Addendum No. 1

Sun Valley 4 Pump Station Abandonment and Zone 3 to Zone 4 PRS Addition

TMWA Bid No.: 2016-027

October 10, 2016

1 PRESSURE REGULATION STATION
SCALE: 1/2" = 1'

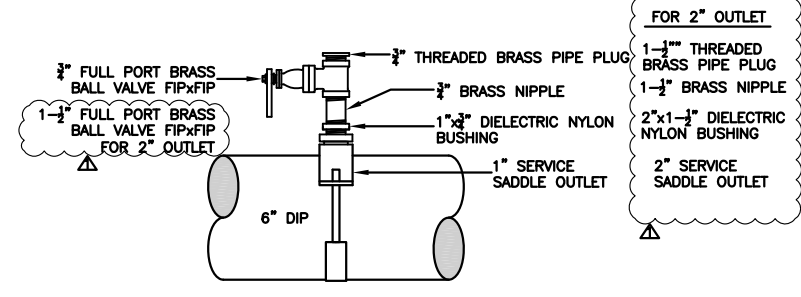
Replace W3 with the attached. A 2-inch outlet has been added to the interior vault piping per the revised W3 plan sheet included in this addendum.

REVISION	DESCRIPTION	BY	APP	DATE
Δ	ADDENDUM 1 - ADDED 2" OUTLET	SHB	BT	10/10/18
